Response to CEC Data Requests Set Two – No. A147

Amended Application for Certification
for
HYDROGEN ENERGY CALIFORNIA
(08-AFC-8A)
Kern County, California

**RESPONSE TO DATA REQUEST A147
FROM CALIFORNIA ENERGY COMMISSION (CEC)**

FIGURE A147-1

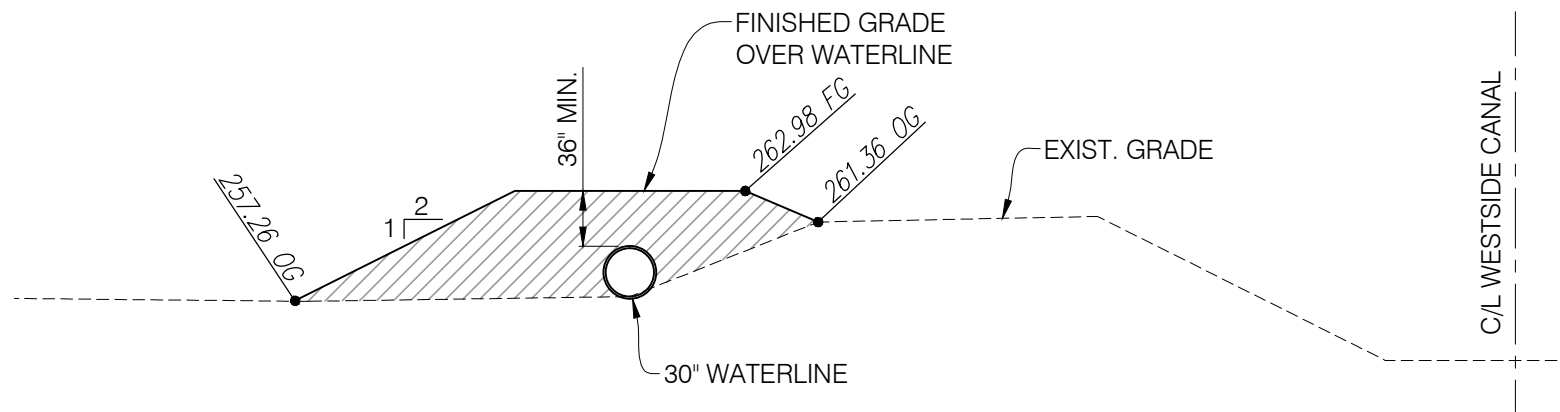
A147. Provide more detailed engineering drawings, showing where exactly the process water pipes will be placed in cross-section of levee. Provide proof, such as historic documents or test results, demonstrating the depth of fill used to build the levee, thereby proving that the sites along the pipeline will be successfully avoided.

In the vicinity of these identified resources, the depth of the levee fill is insufficient to accommodate the pipe without excavating into the native soils. Therefore, the avoidance approach in these areas is to place the pipe adjacent to the levee above the existing ground surface and then place fill over the pipe. A typical section showing the pipeline installation proposed for these areas is provided on Figure A147-1.

For the remainder of the pipeline installation, BVWSD will install the pipeline within the existing levee road fill.
